STAFF RECOMMENDATION

751 Benton Avenue

August 20, 2014

Application: New construction-addition

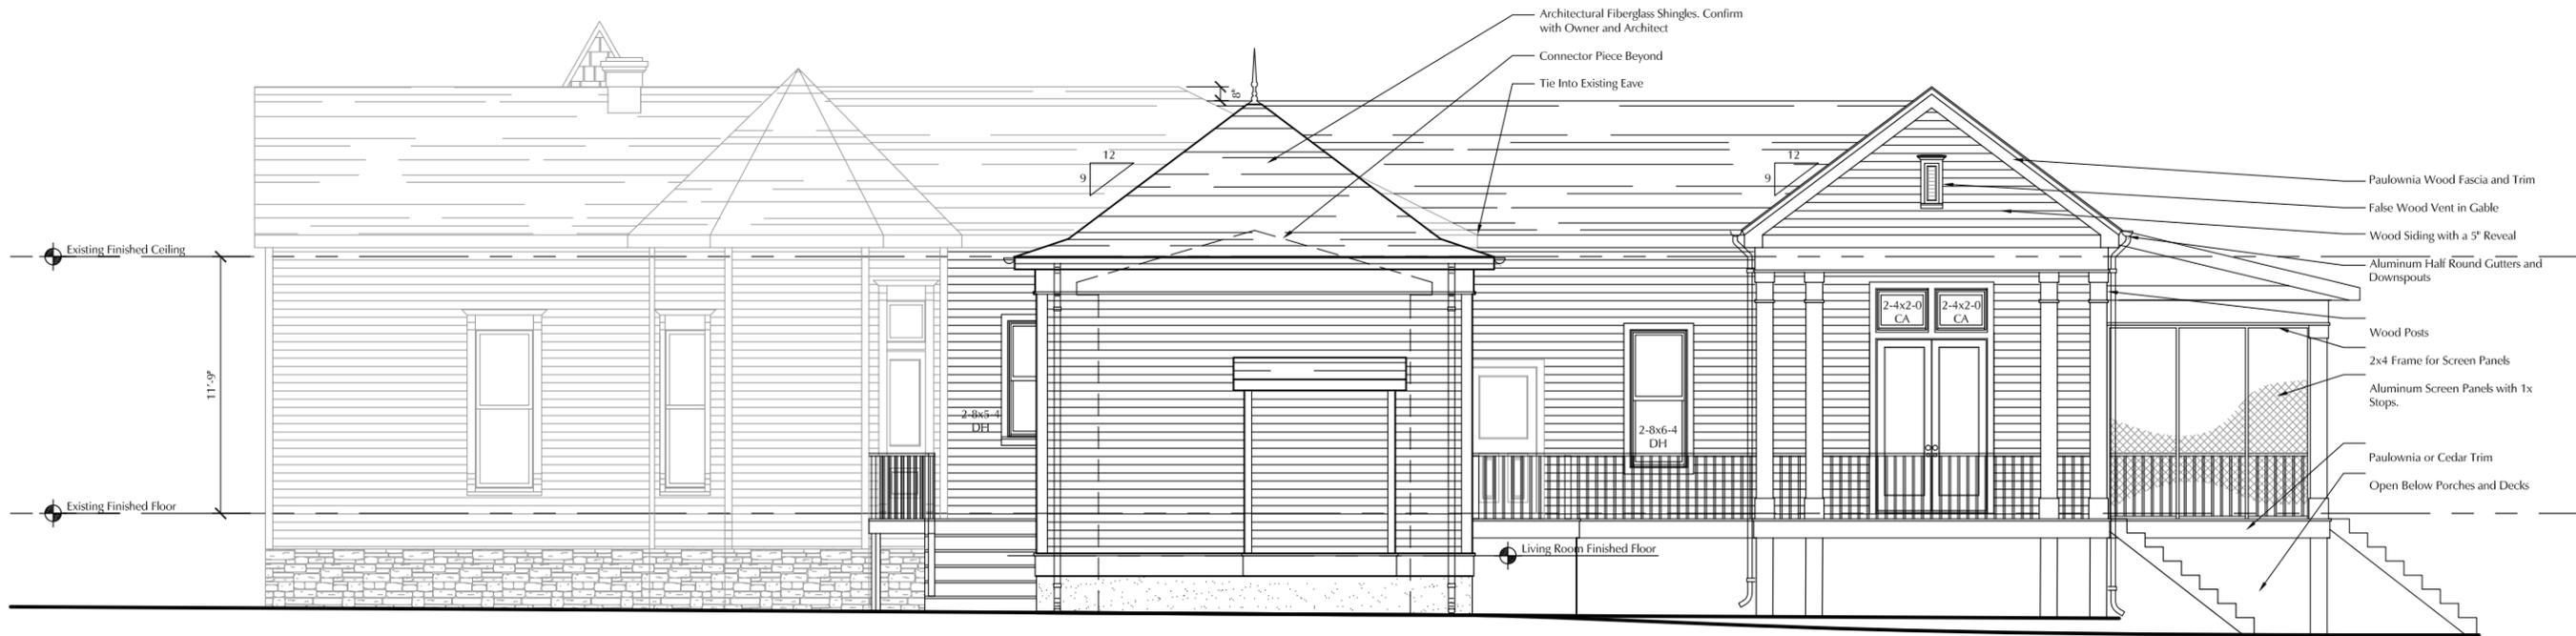
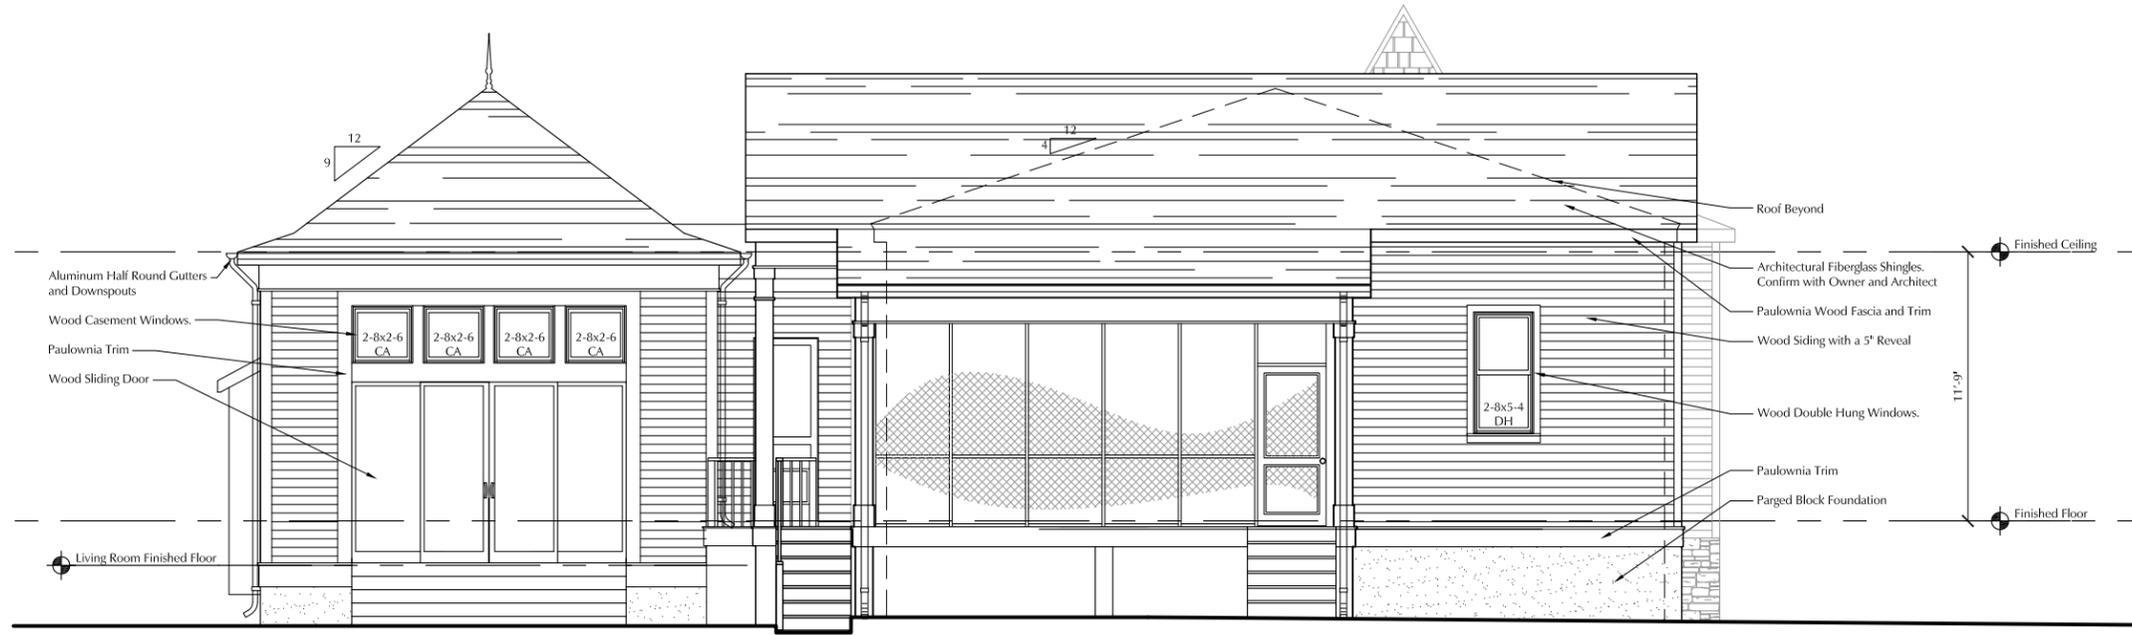
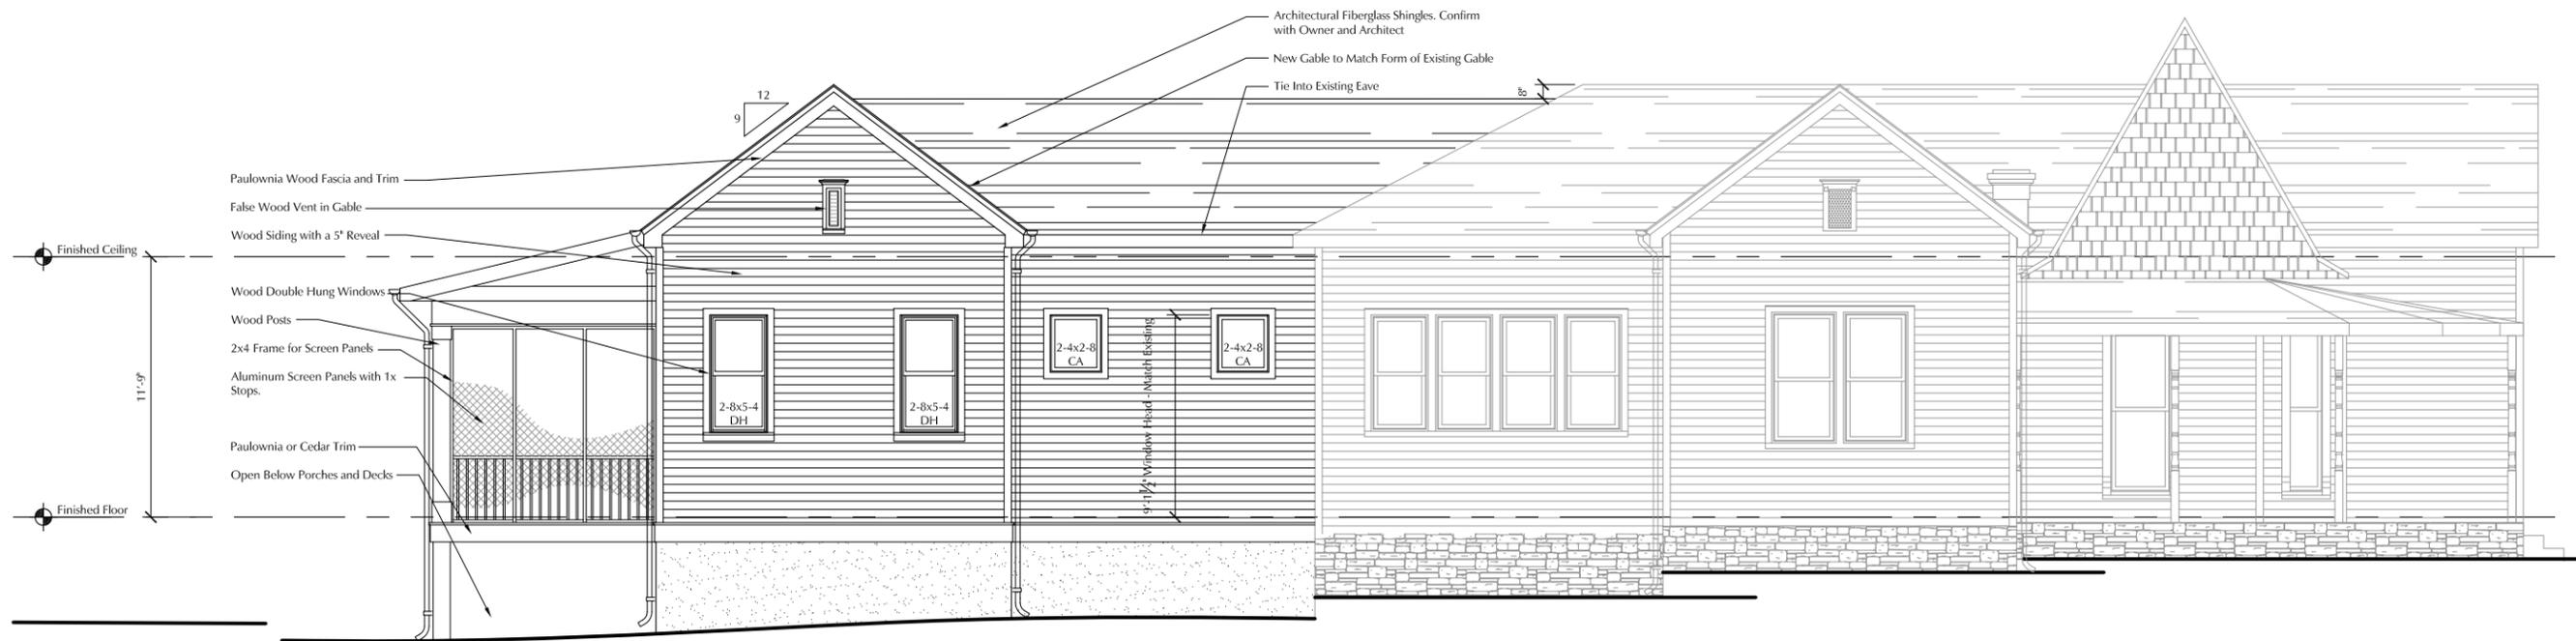
Design, Height and Scale: The rear addition will be twenty-nine feet and seven inches (29’7”) from the rear wall of the house, and will inset two feet (2’) on the left side and

one foot four inches (1'4") from the right. The foundation height will match that of the house. The rear addition's eave height will also match that of the house.

The side addition will add twenty-two feet (22') to the side of the house but only be nineteen feet and eight inches (19'8") deep. The side addition's eave height is one foot (1') lower than the house's eave height. Staff finds the addition to be appropriately subordinate to the historic house, and meets sections III.B.1, III.B.2.a and III.B.2.b of the design guidelines.

Proportion and Rhythm of Openings: The plans submitted indicate no changes to the window and door openings on the existing house. The windows on the proposed addition are generally twice as tall as they are wide, meeting the historic proportions of openings. The square windows are acceptable in the proposed location toward the rear of the addition. There are no large expanses of wall space without a window or door opening. Staff finds the project's proportion and rhythm of openings meet Section III.B.1 and III.B.2.g.

Materials, Texture, and Details and Material Color: Materials for the additions will be wood siding with a five inch (5") reveal and vertical siding. Trim will also be wood. The foundation will be concrete block with a parge-coat finish, and the roof will be architectural fiberglass shingles in a color to match the existing roof. The framing and steps for the rear porch will be wood. The windows and doors will be wood; Staff requests to approve the final window and door selections prior to purchase and

The rear addition has a side-facing gable also with 9/12 pitch, matching the existing gable on the house's left side. The side addition will have a hipped roof with 9/12 pitch. these roof forms are appropriate historically and meet sections III.B.1 and III.B.2.e of the design guidelines.

Staff recommends approval of the proposed addition with the condition of final approval of the details, dimensions and materials of windows and doors prior to purchase and installation.
